PROJET : PWGSC - Relocation of the Canada Revenue Agency (6th Floor – West Tower)
Guy-Favreau Complex
Invitation N° : EF944-172386
Reference : R.078221.001
N/D : 160822

ADDENDUM N° A-03

FRAME TYPE

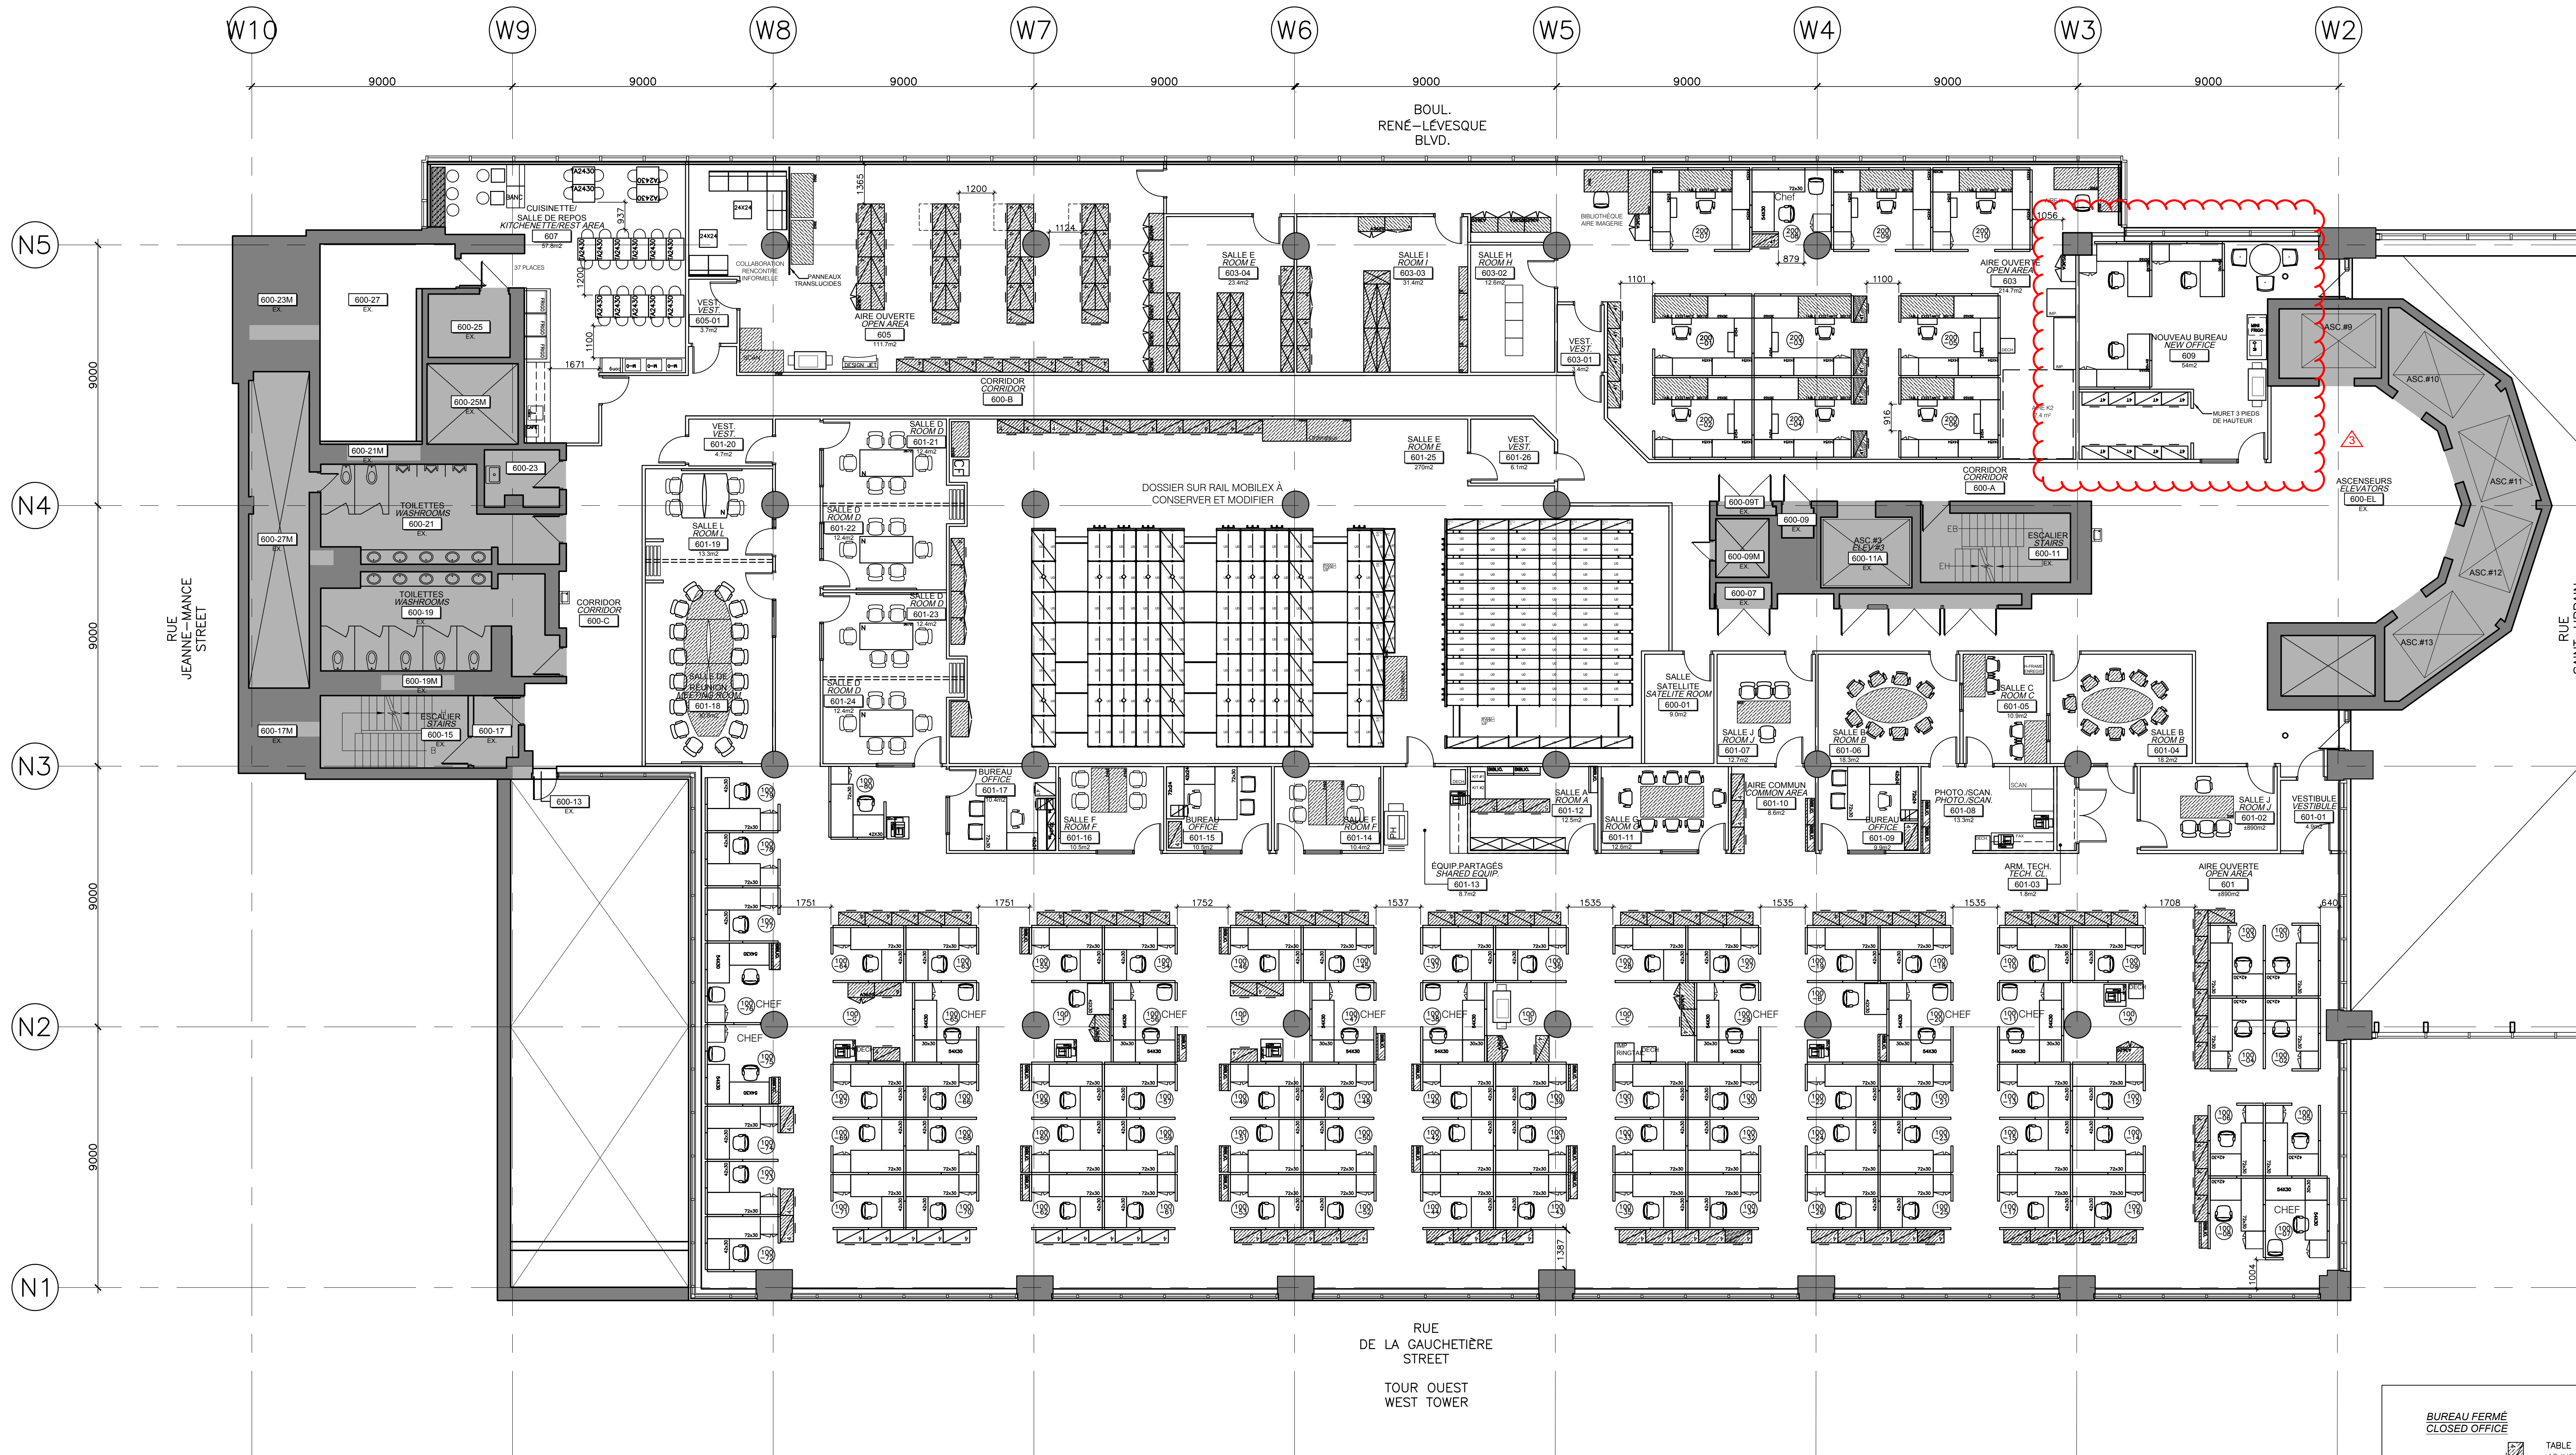
Q3. *On the Door and Frame Schedule, the specified glazing for frame type C2 is TH1 + TH2. On the Typical Elevations, the required glazing is VS1 and VS2. Which one should we use?*

- .1 In Door and Frame Schedule on page 2, on the line of door 609, modify frame type with C2.
- .2 In Door and Frame Schedule on page 2, on the line of door 609, modify GLAZING in the FRAMES column for TH3+TH4.
- .3 Page 4 illustrating glazing types for all frames is re-issued in the annex.

LIST OF DOORS WITH TH1+TH2 GLAZING (SEE DOOR AND FRAME SCHEDULE):
601-09, 601-11, 601-14, 601-15, 601-16, 601-17, 601-18, 601-19

LISTE OF DOORS WITH 45 min ULC RATED GLAZING TH3+TH4 (SEE DOOR AND FRAME SCHEDULE):
601-21, 601-22, 601-23, 601-24, 609

1 PLAN D'AMÉNAGEMENT DU MOBILIER – 6ème ÉTAGE TOUR OUEST
FURNITURE FLOOR PLAN – 6th FLOOR WEST TOWER

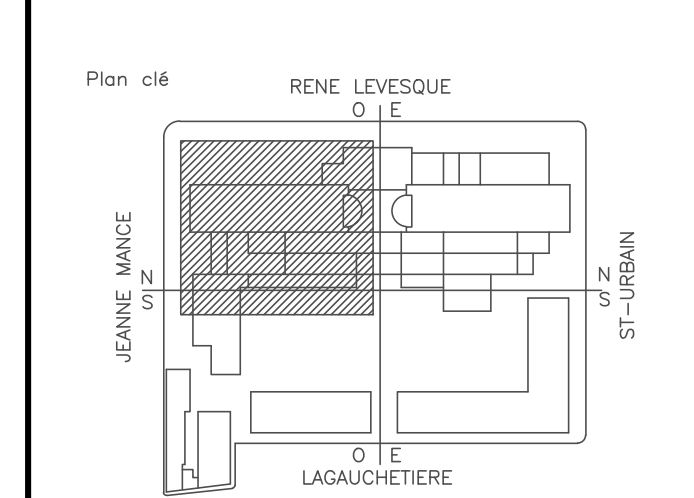
- .1 Furniture is added in room 609 for reference purposes only, as illustrated on sheet A06 re-issued in the annex.
